AGIPD Mechanics

XDAC Meeting 08.05.2015

Vacuum chamber

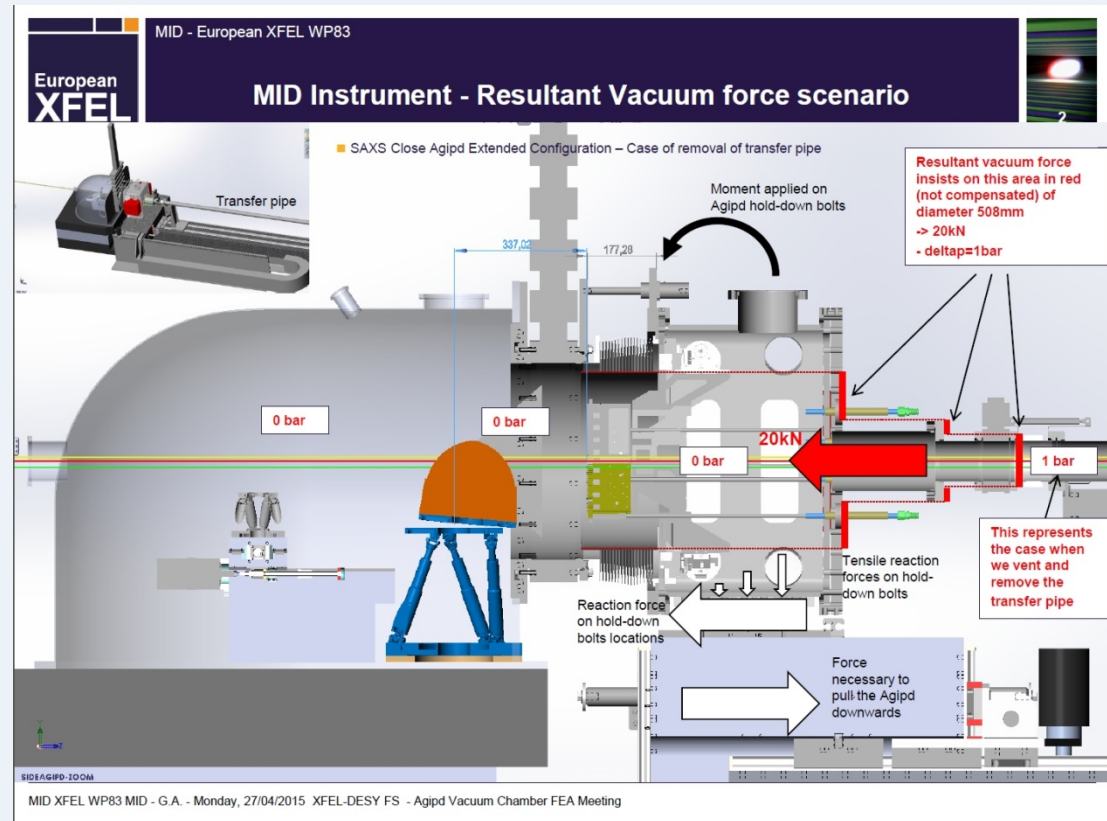
- 12x M12 screws tight enough to withstand tensile forces?
- Deflections acceptable?
- Stress in base plate acceptable?

The customers do not agree with the tensile load of 0N on the hold-down screws for the "worst case" load, because the resultant axial force applies a torque (see black bended arrow in the sketch). The customers ask to clarify this.

This comment is correct. The effective Tensile Operating Load acting on the bolts is not zero because of a Bending Moment resulting from the 20 [kN] vacuum force acting at a moment arm of approximately 365 [mm]. There are no tensile operating bolt loads due to gravity or atmospheric pressure. Atmospheric pressure loads in vertical direction are balanced and gravity loads are directly transferred through the baseplate to the sub-structure (this load path does not go through the

bolts.). A re-run of the analysis without gravity loads applied and **with twelve individual Hold-down Bolt Boundary Condition definitions** resulted in the following Reaction Forces and corresponding Bolt Stresses due to Operating Loads:

Note-1: Above Bolt Loads are due to 100% of the applied 20 [kN] Vacuum Force
 Note-2: All calculated Hold-down Bolt Stresses are acceptable.

Figure 3.2.2-2: Calculated Directional (UY) Deflection in vertical direction and perpendicular to the beamline ('downstream gate valve closed' load case).

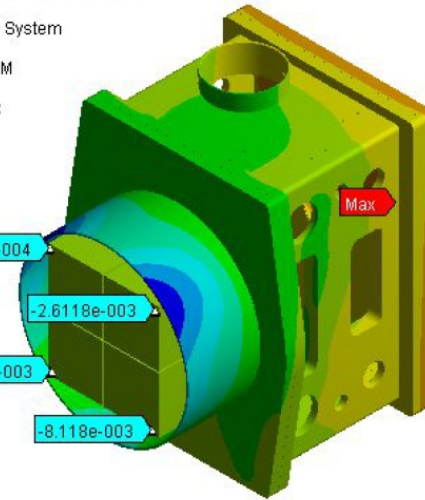
Deflections acceptable?

The maximum calculated UY differential deflection at the quadrants is $(140 / 330) * (8.148E-03 - 0.289E-03) = 3.33E-03$ [mm] over a length of 140 [mm]. The maximum allowable deflection per /2 is $100E-03$ [mm]. The edge-to-edge UY distance between Quadrant outer corners is 330 [mm], for modeling purposes only.

Figure 3.2.1-3: Calculated Baseplate VonMises Equivalent Stress due to Operating Conditions (full)

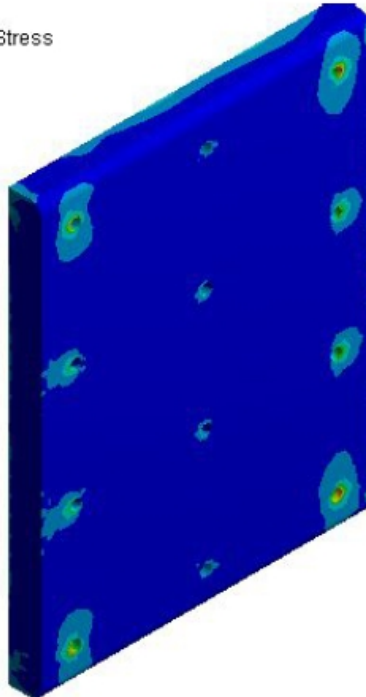
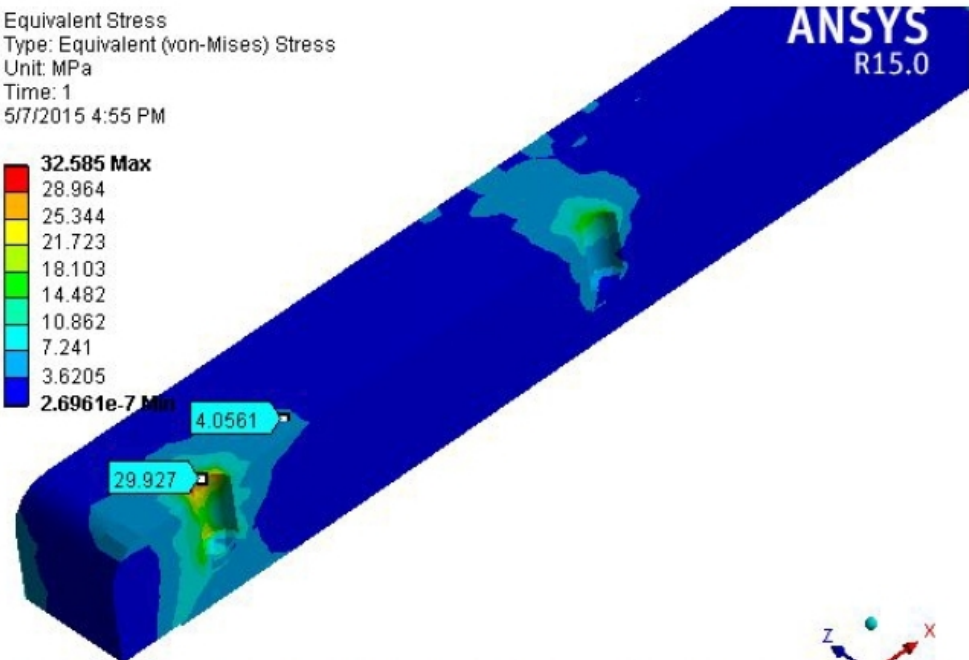
Stress in baseplate acceptable?

Max. stress = 129 Mpa

Equiv. Stress = 25% of max. stress
